## Stag Brewery

### Masterplan and Detailed Design and Access Statement Addendum

This document replaces the Design and Access Statement Addendum documents, dated May 2019.

ORIGINAL PROPOSAL: MASTERPLAN HEIGHTS

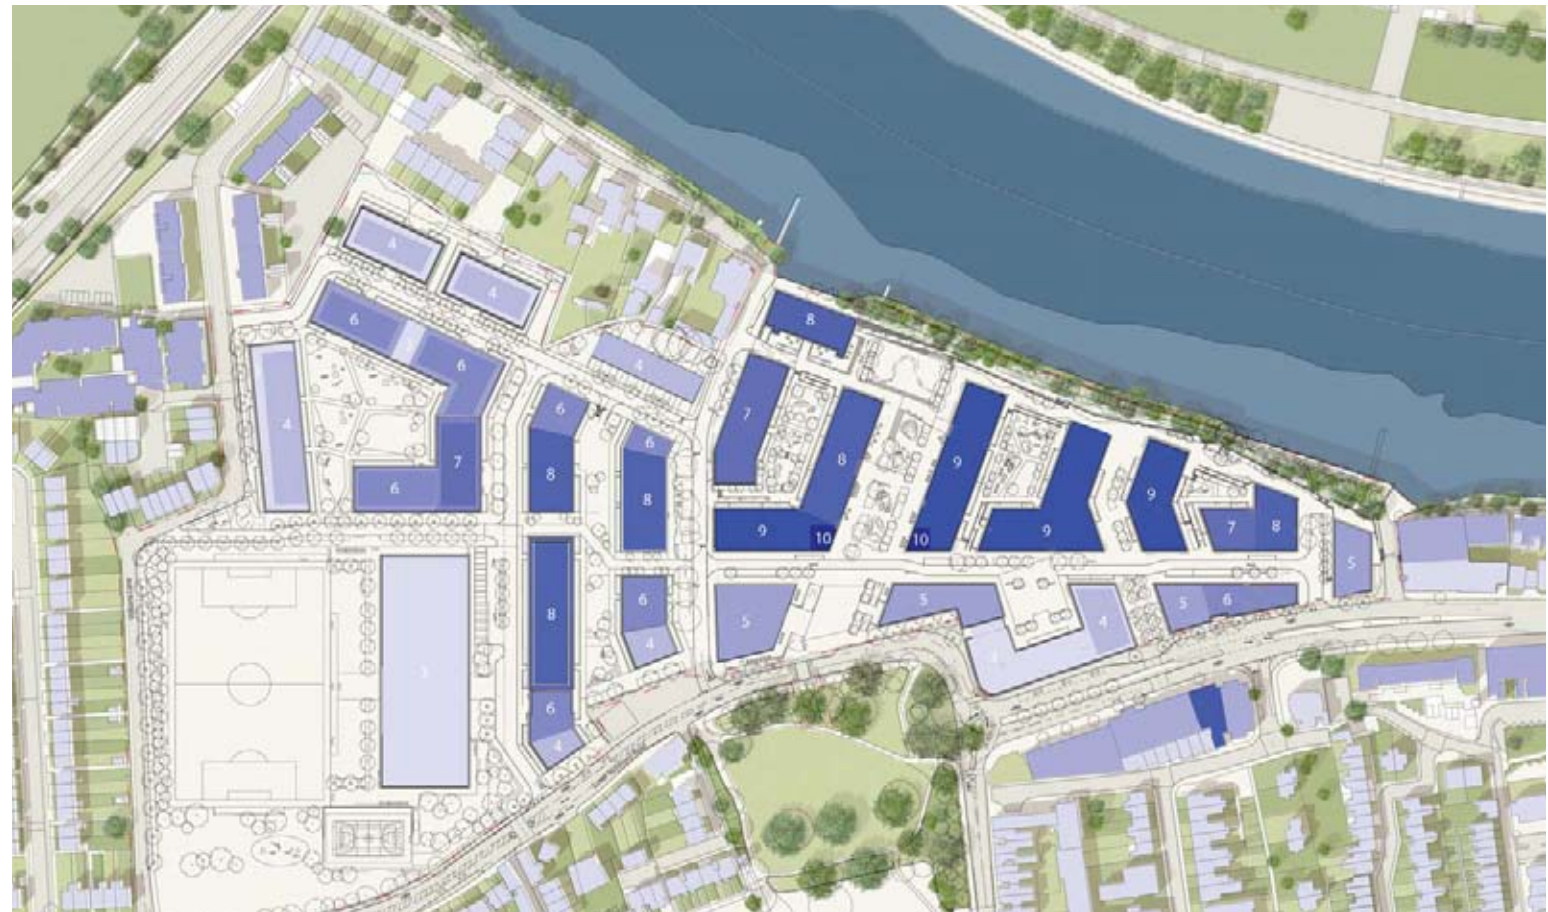
The heights of the revised buildings now range from three storeys up to ten storeys. The tallest elements of the masterplan are proposed at the centre of the site along the new Thames Street. Height increase has been more limited around The Maltings Building so it retains an element of prominence. Buildings 6 and 10 on Mortlake High Street have been slightly increased to more closely meet the maximum targets of the Planning Brief but without dominating the streetscape. Likewise, the massing to the perimeter of Development Area 2 has also been slightly increased to optimise the residential quantum, however the elements of Building 19 seen from the river have been limited in their height increase and have been divided at upper floors to reduce their massing.

REVISED PROPOSAL: MASTERPLAN HEIGHTS

ORIGINAL PROPOSAL: BUILDING 2 TYPICAL FLOOR PLAN (16 units/ 53 habitable rooms per level)

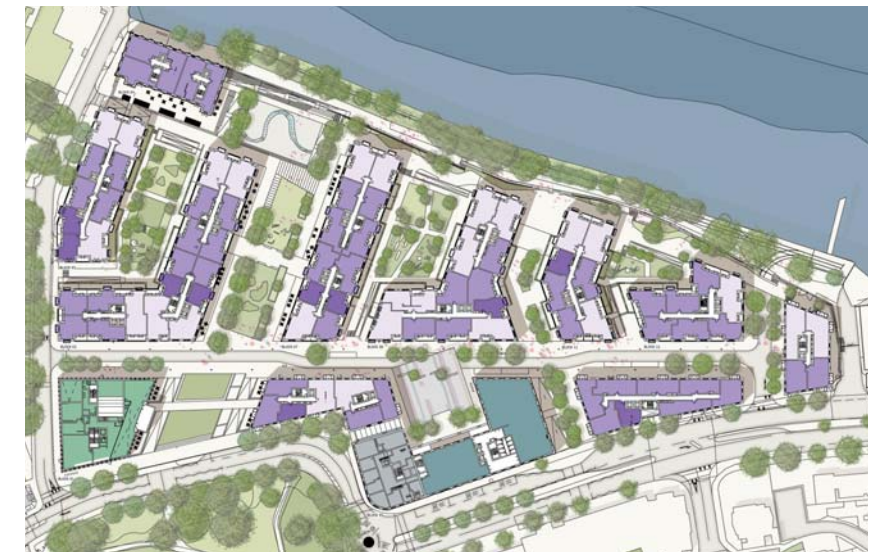
- Building 2 has been redesigned to optimise the residential floor area and remove one of the three cores. This has resulted in a slightly different ground floor level entrance configuration. It has also resulted in one of the cores at the typical level serving 9 units and the other serving 8 units (as opposed to 5, 5 and 6 units per core). The benefit of this layout is an optimised GIA and number of habitable rooms per level (increase from 53 in addendum application to 54 per level in revised). The cumulative changes to this building (including height) have resulted in an uplift of 80 habitable rooms (from 321 to 401) and as a consequence have significantly increased the scheme's ability to deliver a higher percentage of affordable housing by habitable room count.

REVISED PROPOSAL: BUILDING 2 TYPICAL FLOOR PLAN (17 units/ 54 habitable rooms per level)

ORIGINAL PROPOSAL: DEVELOPMENT AREA 1 TYPICAL FLOOR PLAN

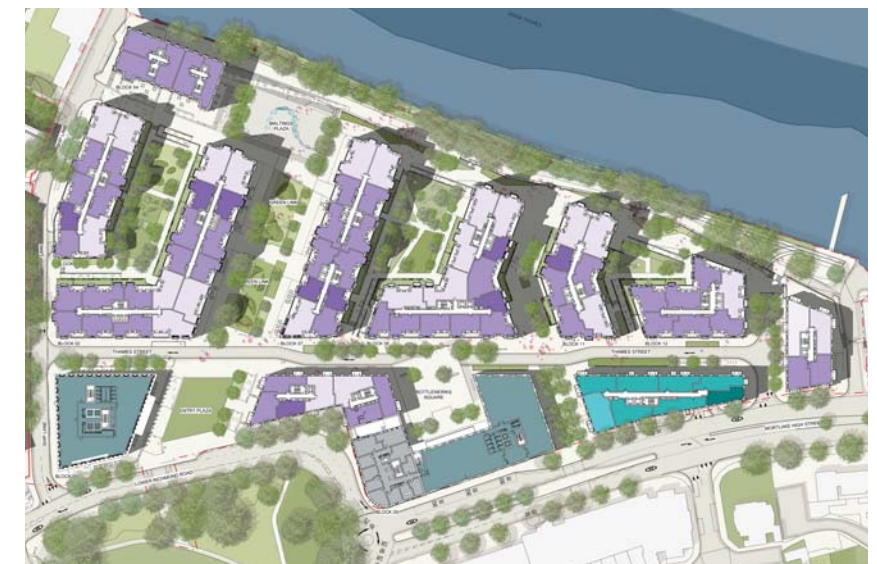
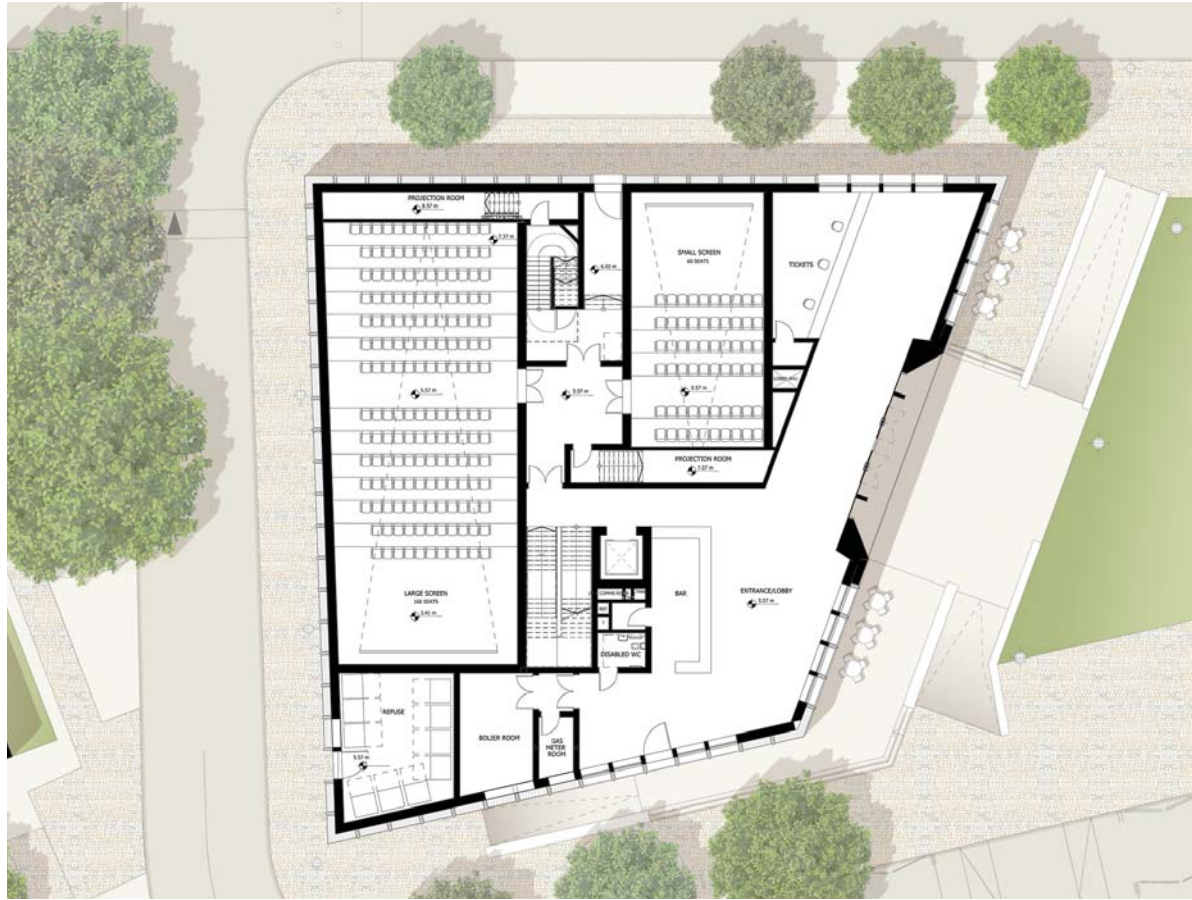
The main changes to the warehouse typology residential buildings (6, 9 and 10) are as following:

- Due to an increase in number of storeys, Building 6 has been redesigned to contain one single core that contains two lifts. This has resulted in the reconfiguration of the ground floor layout to provide a single point of residential entrance with associated refuse storage. The mix of layouts per level has also been adjusted to meet the requirements of the intermediate tenure that the building now constraints.

The main changes to the warehouse typology residential buildings is to Building 10, which has been re-configured to incorporate an appropriate mix of intermediate units (less than three bedroom units) and optimise the efficiency of the layout to improve the habitable room count. There have been more minor amendments to the layouts of Building 6.

REVISED PROPOSAL: DEVELOPMENT AREA 1 TYPICAL FLOOR PLAN

ORIGINAL PROPOSAL : BUILDING 1 (CINEMA) GROUND FLOOR PLAN

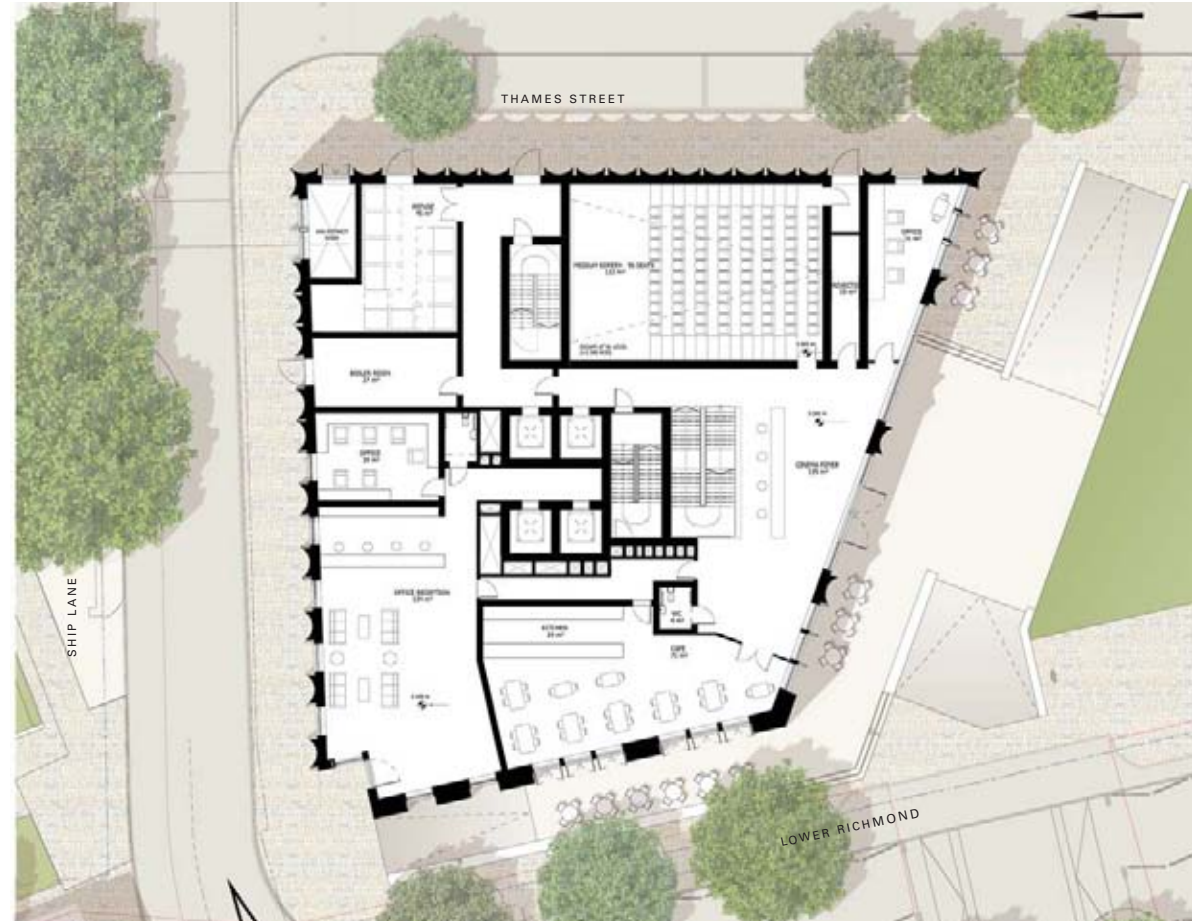
The standalone cinema building has remained the same in terms of footprint, but has been re-designed to serve as a mixed use building containing both cinema and office space.

The cinema accommodation has been condensed into two storeys of accommodation, the lower of which will sit at a lower ground floor level. The office accommodation will sit above the cinema space and be accessible via a ground floor level reception area at the junction of Lower Richmond Road and Ship Lane. Increased active frontage in the form of a small cafe (serving both cinema and office facilities as well as the general public) will be provided at ground floor level facing Lower Richmond Road. The cinema entrance will remain facing the entrance to the Green Link.

REVISED PROPOSAL: BUILDING 1 (CINEMA) GROUND FLOOR PLAN

ORIGINAL PROPOSAL: BUILDING 5 FIRST FLOOR PLAN

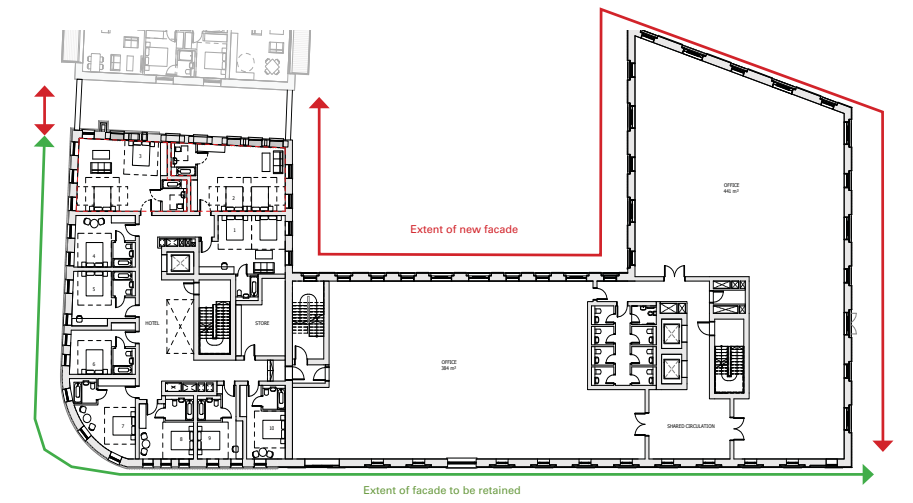
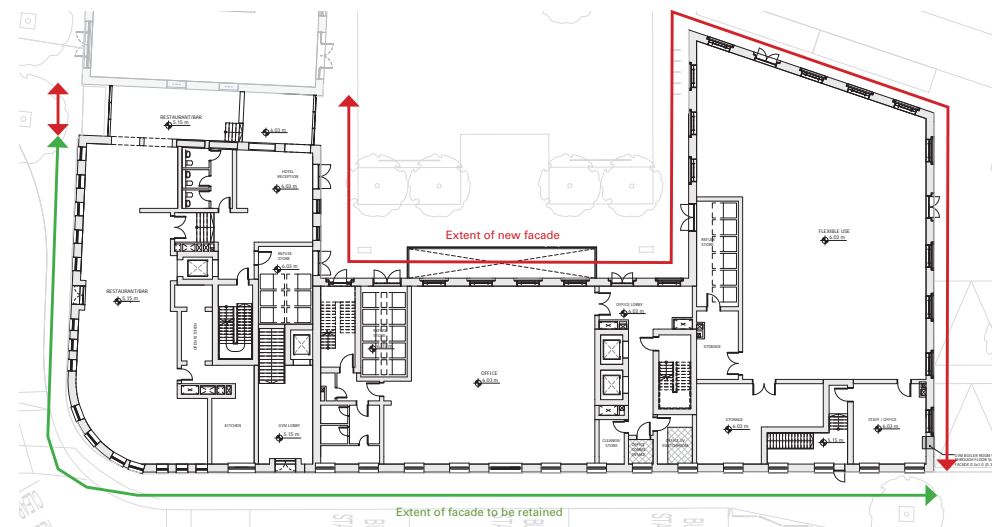
7.5.3 Former Bottling Building and Hotel Layout (Building 5)

Building 5 has been revised slightly to remove the Gym use and increase the flexible use at ground and lower ground levels. The proposed footprint and extent of facade retention remains the same as previously proposed with only minor changes to the elevations.

REVISED PROPOSAL: BUILDING 5 FIRST FLOOR PLAN

BUILDING 6: RELATIONSHIP WITH BUILDINGS OPPOSITE

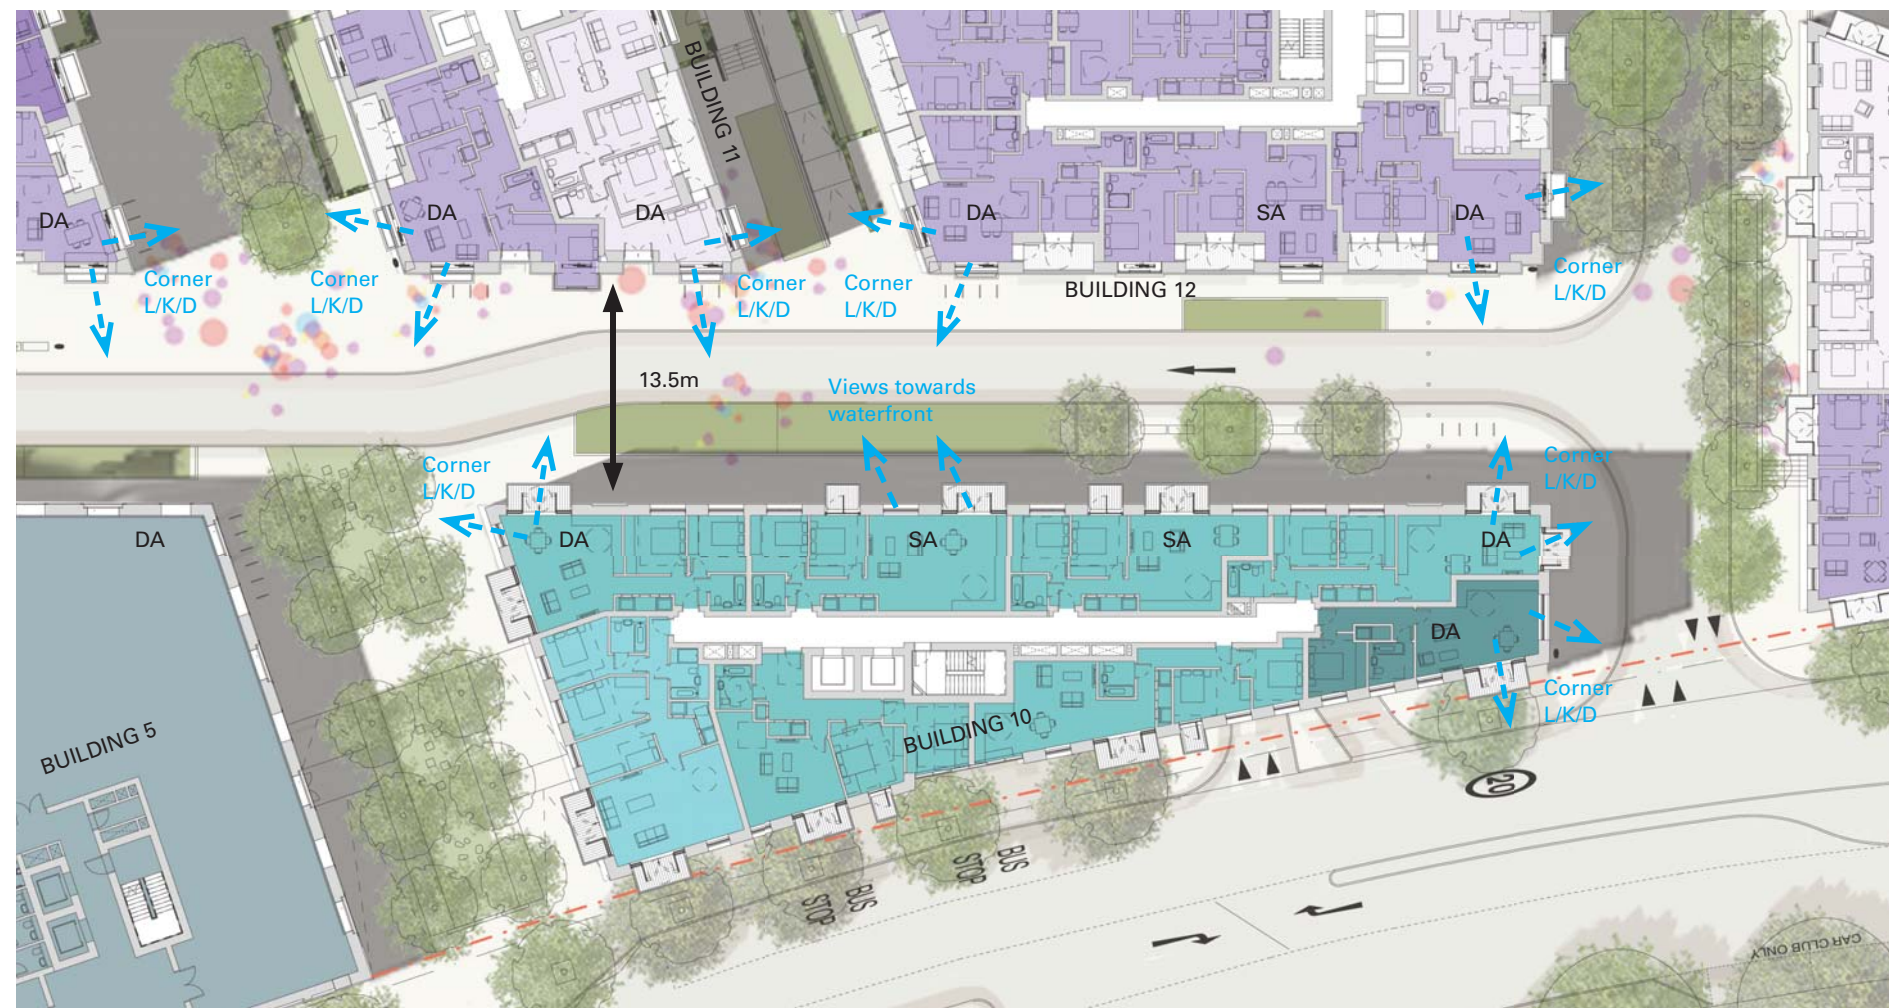
9.2.2 In occasional circumstances where building faces are separated by less than 15m, the following techniques have been adopted to ensure privacy is maintained:

- Habitable rooms have been set back behind balconies (1.5m deep) and balustrades that provide screening.
- Living rooms have generally been provided in corner locations, where a choice of view is provided along with opportunity to choose to obscure the view from (and into) particular windows if need be.
- Windows to some of these dual aspect rooms can be strategically obscured to mitigate privacy issues.
- Where the aforementioned techniques cannot be used, facing rooms have been limited to living rooms facing living rooms and bedrooms facing bedrooms.
- Internal daylight and sunlight levels have been tested to ensure minimum standards are achieved or improved upon.
